RENESAS TECHNICAL UPDATE

Product Category	MPU/MCU	Document No.	TN-RX*-A0280A/E	Rev.	1.00
Title	Errata Regarding Setting of the RCR4.RCKSEL Bit for the RX65N Group and RX651 Group MCUs		Information Category	Technical Notification	
Applicable Product	RX65N Group, RX651 Group	Lot No.	Reference Document	RX65N Group, RX651 Group User's Manual: Hardware Rev.2.40 (R01UH0590EJ0240)	
		All

Figure 31.3 Clock and Count Mode Setting Procedure

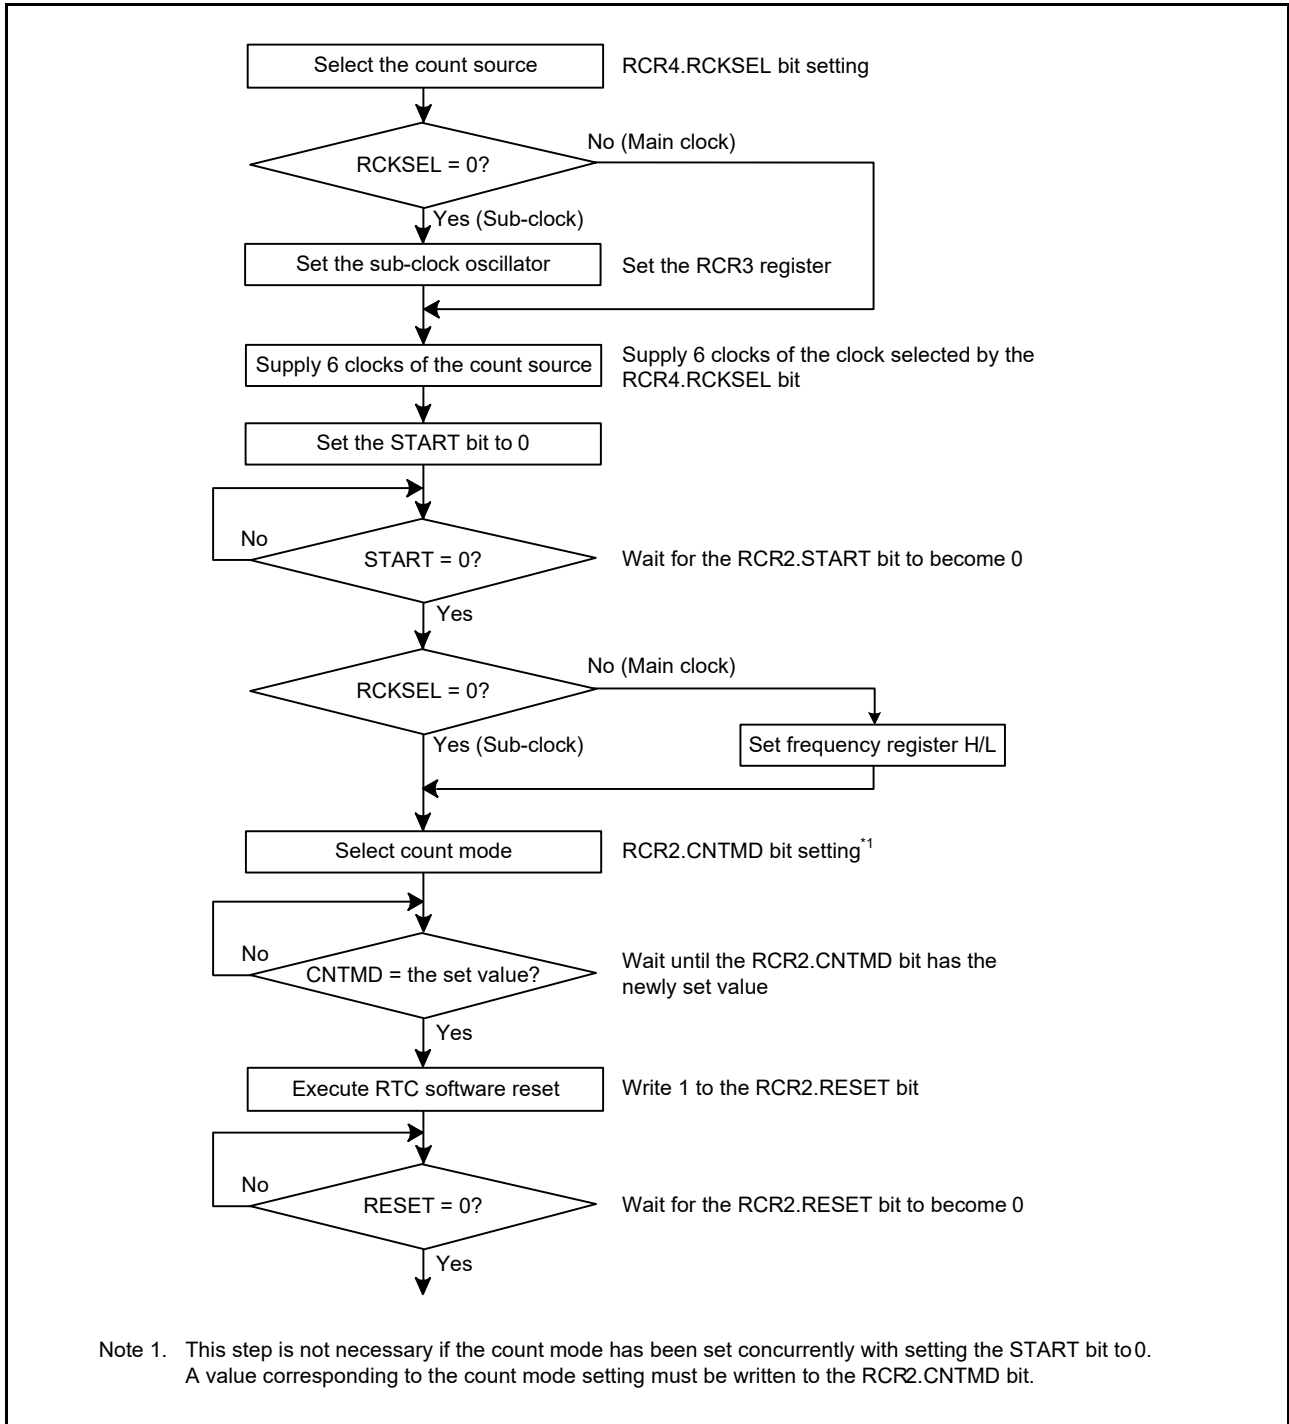
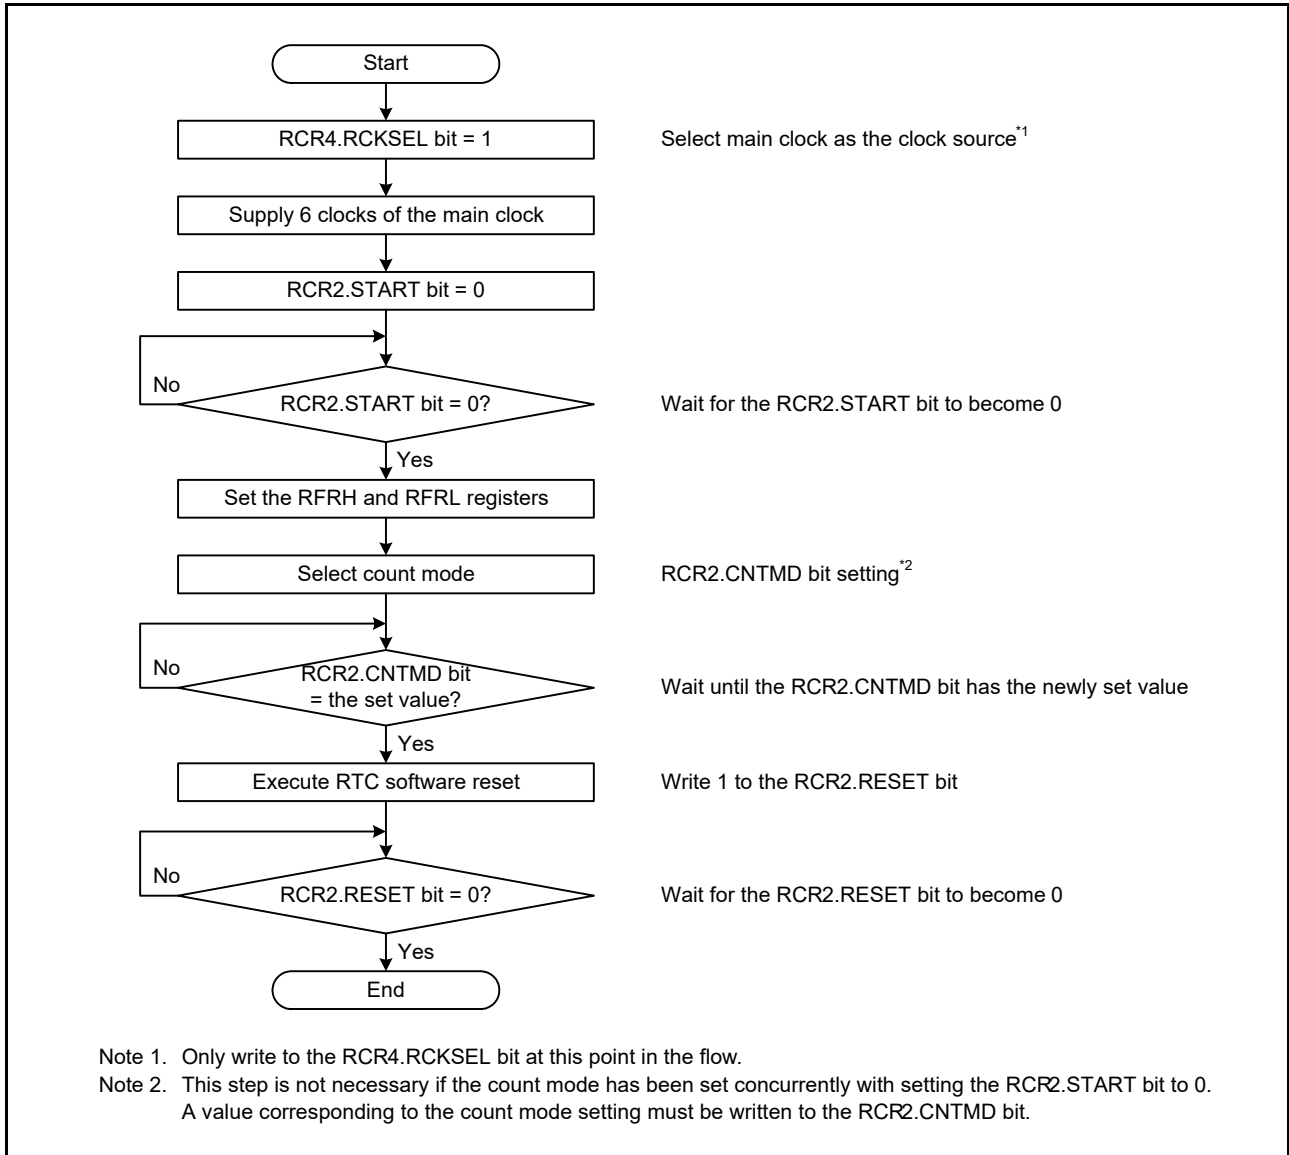
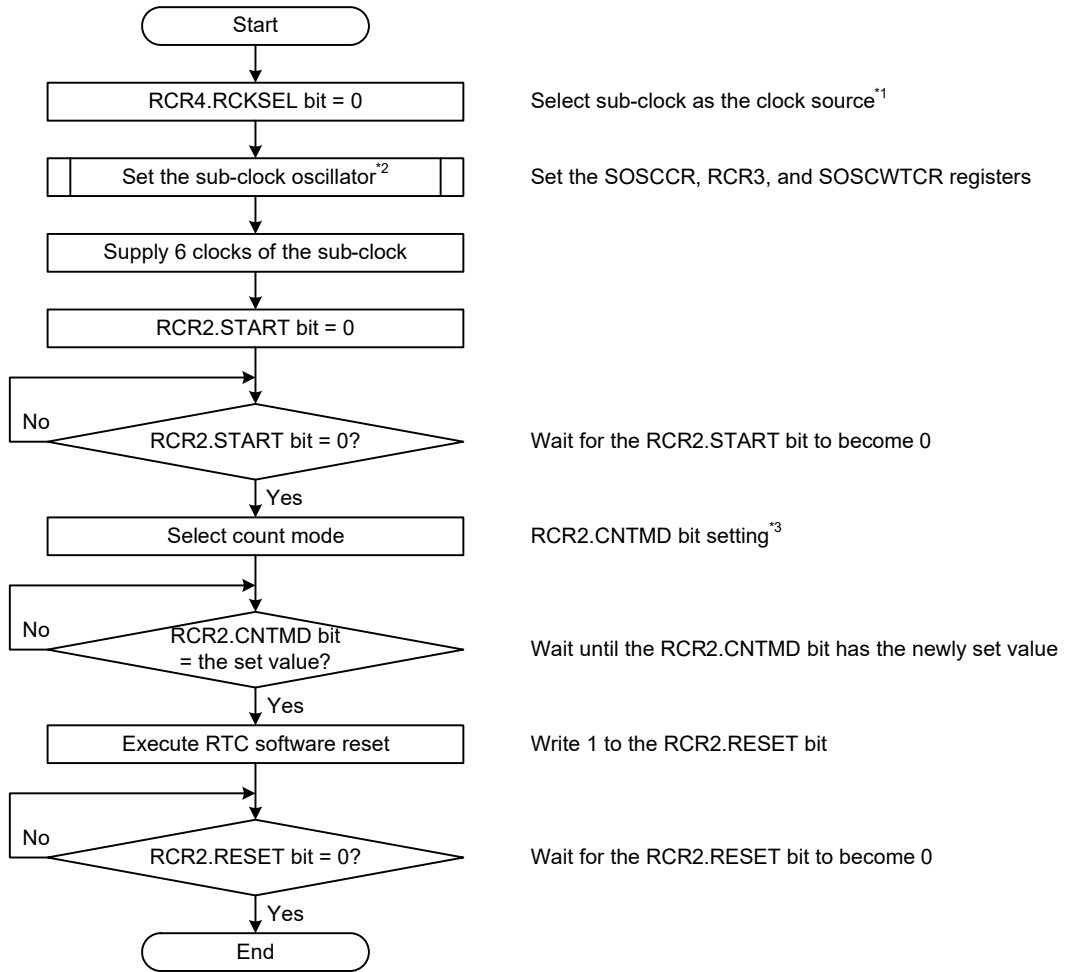
Figure 31.3, Clock and Count Mode Setting Procedure, in section 31.3.2, Clock and Count Mode Setting Procedure, is separated into two flowcharts as follows to suit the clock that is in use.

Note 1. Only write to the RCR4.RCKSEL bit at this point in the flow.

Note 2. For the procedure for setting up a sub-clock oscillator, refer to section 9, Clock Generation Circuit.

Note 3. This step is not necessary if the count mode has been set concurrently with setting the RCR2.START bit to 0. A value corresponding to the count mode setting must be written to the RCR2.CNTMD bit.

Figure 31.14 Initialization Procedure

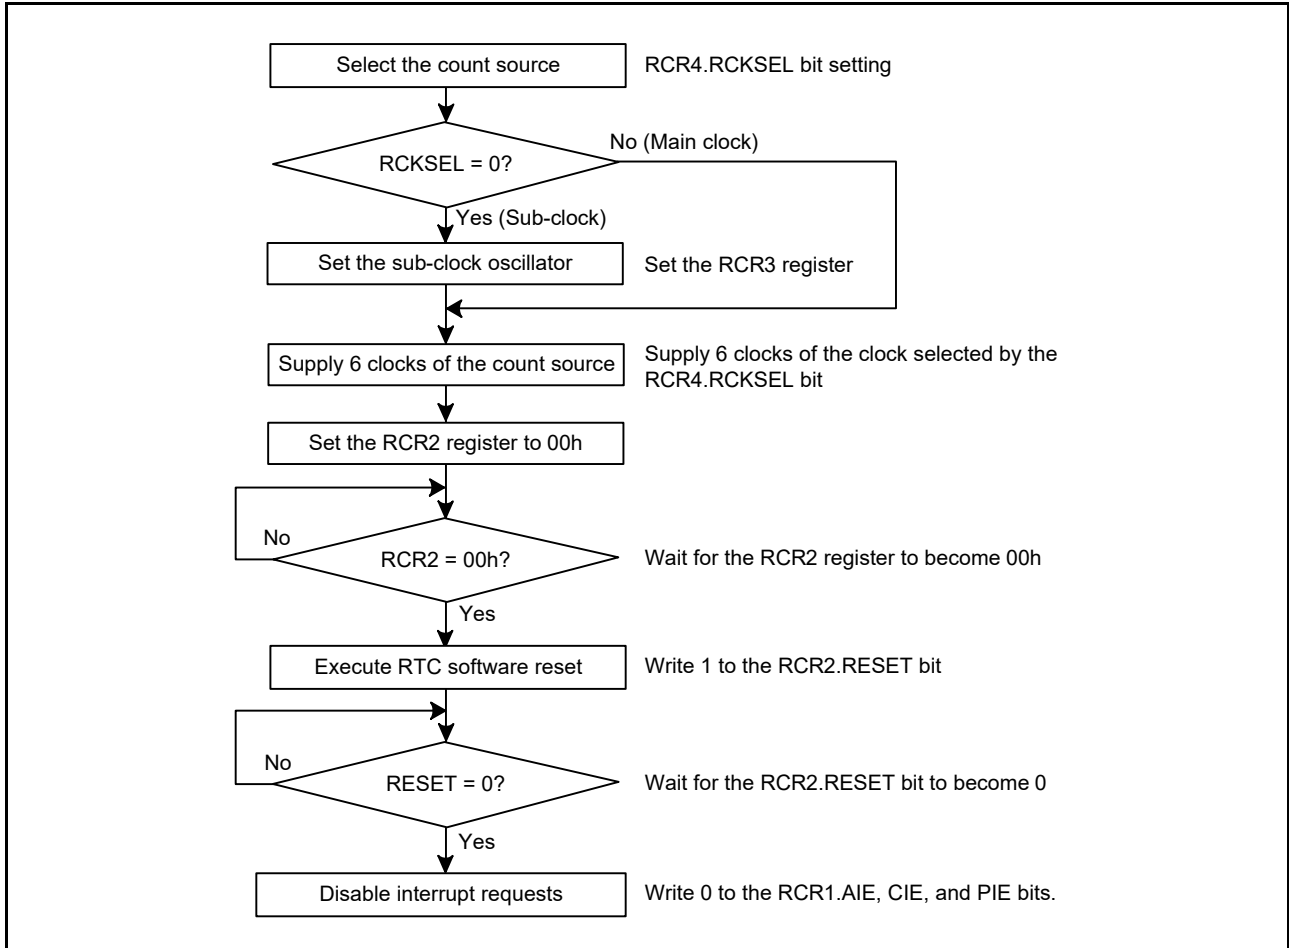
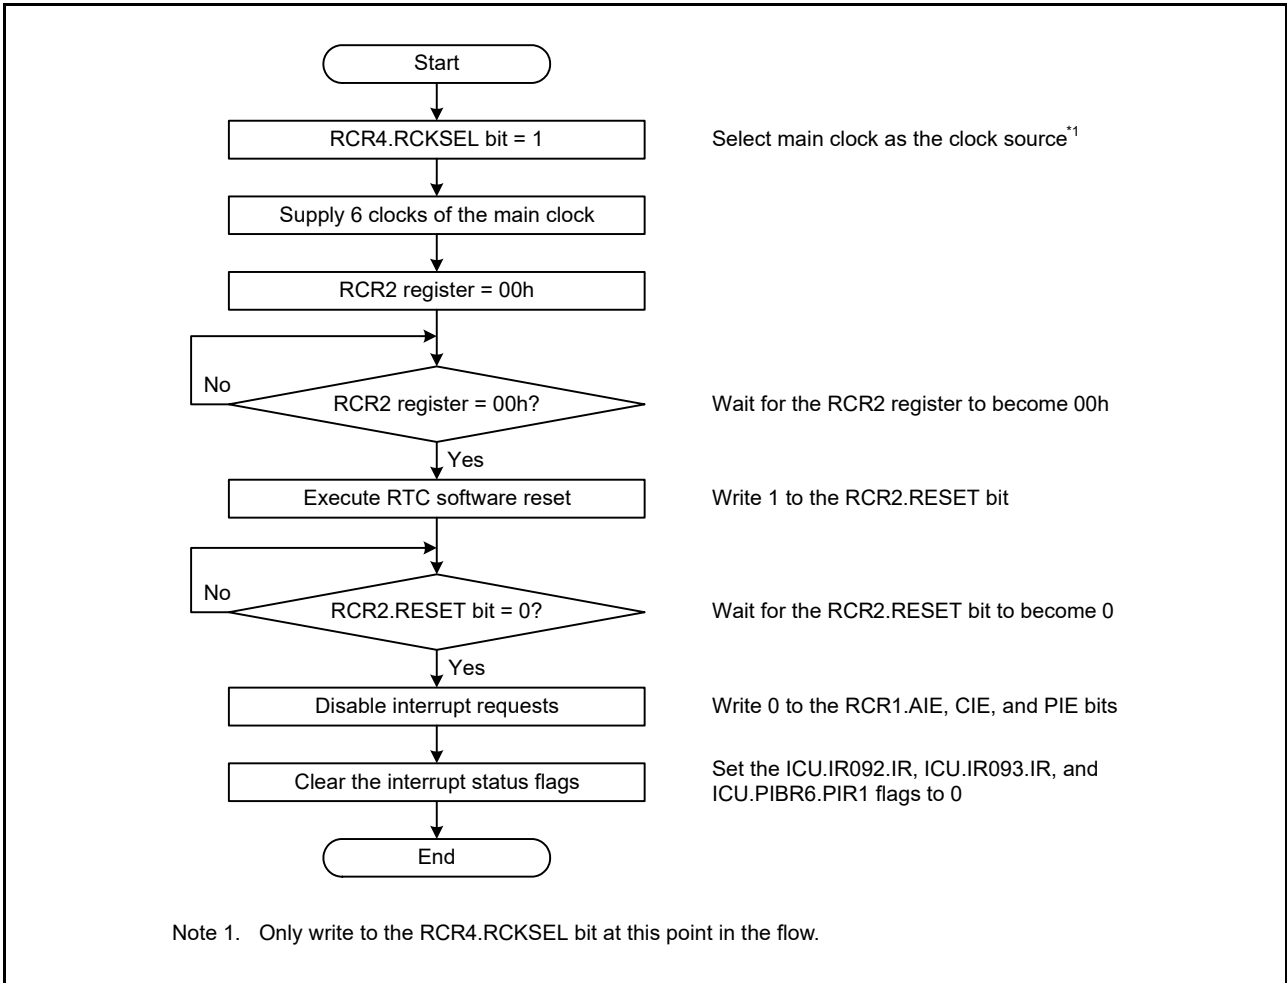
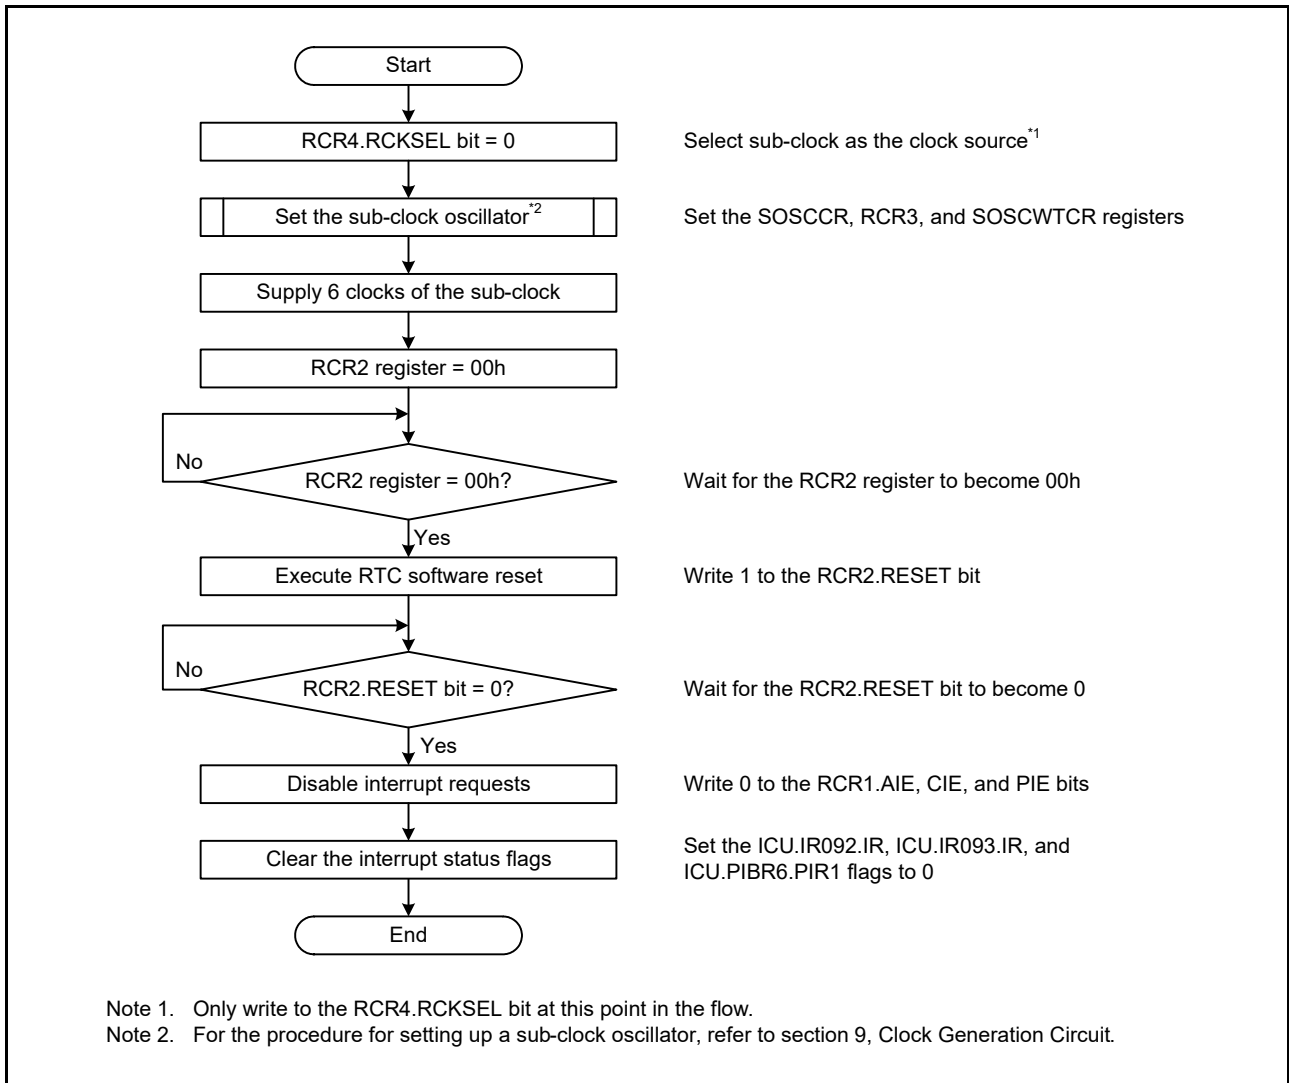
Figure 31.14, Initialization Procedure, in section 31.6.7, Initialization Procedure When the Realtime Clock is Not to be Used, is separated into two flowcharts as follows to suit the clock that is in use. A step of clearing the interrupt status flags is also added to both flowcharts.
